Project	IEEE 802.16 Broadband Wireless Access Working Group < http://ieee802.org/16 >	
Title	Enhancement of the Multicast & Broadcast Rekeying Algorithm	
Data Submitted	2004-11-15	
Source(s)	Seokheon Cho Sungcheol Chang Chulsik Yoon, ETRI	Voice: +82-42-860-5524 Fax: +82-42-861-1966 chosh@etri.re.kr
	161, Gajeong-dong, Yuseong-Gu, Daejeon, 305-350, Korea	
Re:	IEEE 802.16e Security Ad Hoc	
Abstract	The supplementary contents for the efficient rekeying method for the multicast service and the broadcast service	
Purpose	The document is submitted for review by 802.16 Working Group members	
Notice	This document has been prepared to assist IEEE 802.16. It is offered as a basis for discussion and is not binding on the contributing individual(s) or organization(s). The material in this document is subject to change in form and content after further study. The contributor(s) reserve(s) the right to add, amend or withdraw material contained herein.

Enhancement of the Multicast & Broadcast Rekeying Algorithm

Seokheon Cho, Sungcheol Chang, and Chulsik Yoon
ETRI

Figure 137b- MBRA management

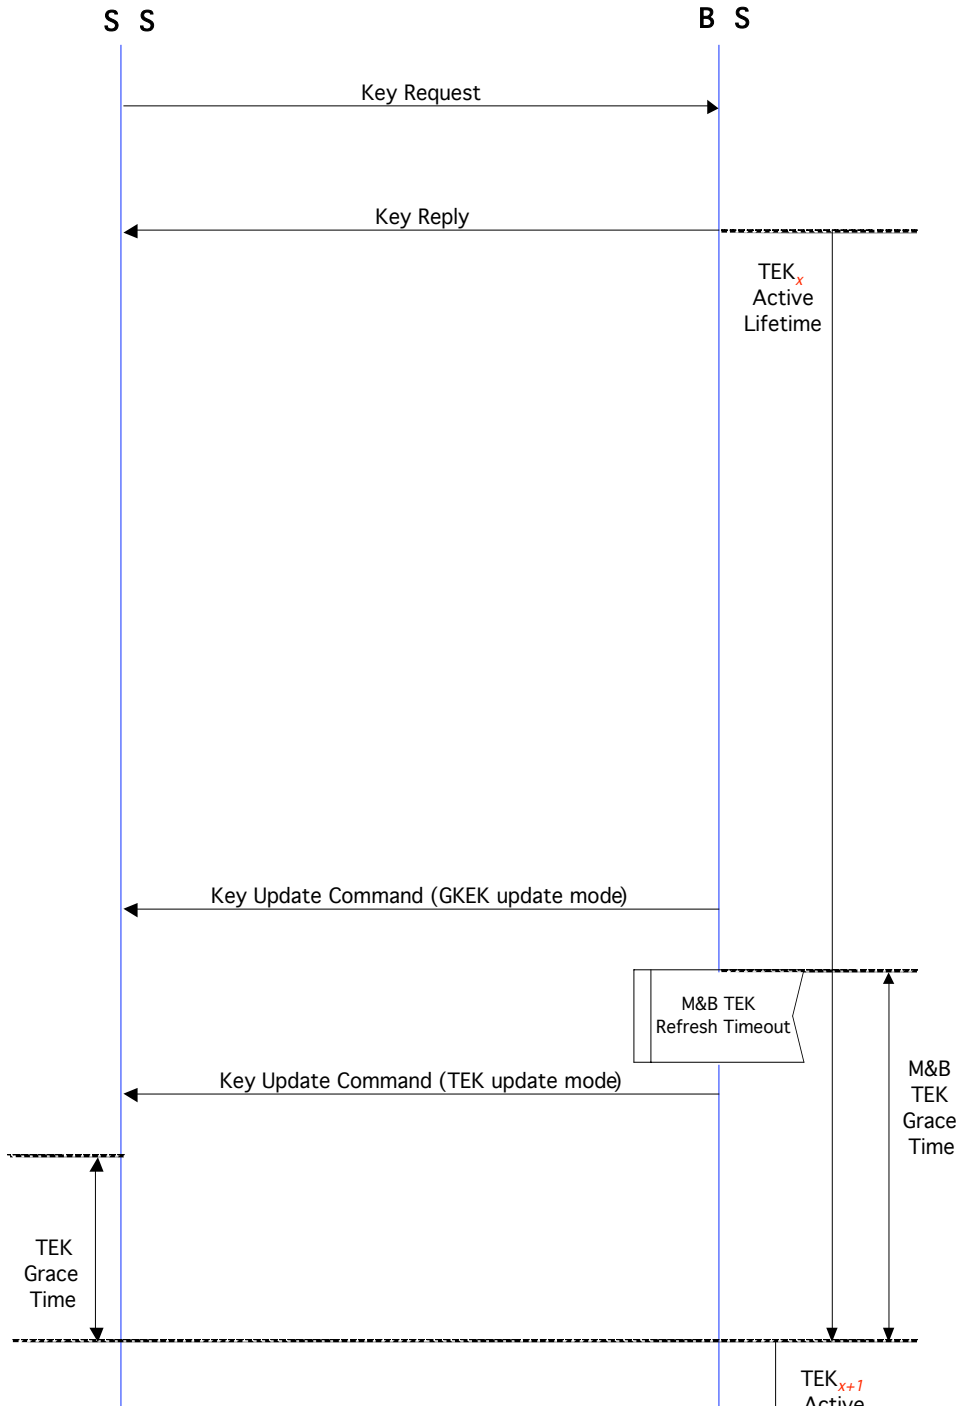
[Modify as the following in section 7.9.1]

The MBRA overall flow is shown in the Figure 137b.

An MSS may get the traffic keying material before an MSS is served with the specific multicast service or the broadcast service. The initial GTEK request exchange procedure is executed by using the Key Request and Key Reply messages that are carried on the Primary Management connection. Once an MSS shares the traffic keying material with a BS, an MSS doesn't need to request the new traffic keying material. A BS updates and distributes the traffic keying material periodically by sending two Key Update Command messages.

A BS manages the M&B (Multicast & Broadcast) TEK Grace Time for the respective GSA-ID in itself. This M&B TEK Grace Time is defined only for the multicast service or the broadcast service. This parameter means time interval (in seconds), before the estimated expiration of an old distributed GTEK. In addition, the M&B TEK Grace Time is longer than the TEK Grace Time managed in an MSS.

A BS distributes updated traffic keying material by sending two Key Update Command messages before old distributed GTEK is expired. The usage type of these messages is distinguished according to the Key Push Modes included in the Key Update Command message.

A BS transmits the Key Update Command message for the GKEK update mode to each MSS served with the specific multicast service or the broadcast service before the M&B TEK Grace Time starts. The purpose of the Key Update Command message for the GKEK update mode is to distribute the GKEK (Group Key Encryption Key). The Key Update Command message for the GKEK update mode is carried on the Primary Management connection. A BS intermittently transmits the Key Update Command message for the GKEK update mode to each MSS in order to reduce the BS's load in refreshing traffic key material. The GKEK is needed to encrypt the new GTEK. The GKEK can be randomly generated in a BS or an ASA server.

A BS transmits the Key Update Command message for the GTEK update mode carrying on the Broadcast connection after the M&B TEK Grace Time starts. The aim of the Key Update Command message for the GTEK update mode is to distribute new GTEK and the other traffic keying material to all SSS served with the specific multicast service or the broadcast service. This GTEK is encrypted with already transmitted GKEK.

If an MSS receives the valid two Key Update Command messages and shares new valid GKEK and GTEK with a BS, then that MSS doesn't need to request a new set of traffic keying material.

If an MSS doesn't receive at least one of two Key Update Command messages, then that MSS sends the Key Request message to get a new traffic keying material. A BS responds to the Key Request message with the Key Reply message. In other words, if an MSS doesn't get valid new GKEK or GTEK, then the GTEK request exchange procedure initiated by a MSS is executed.
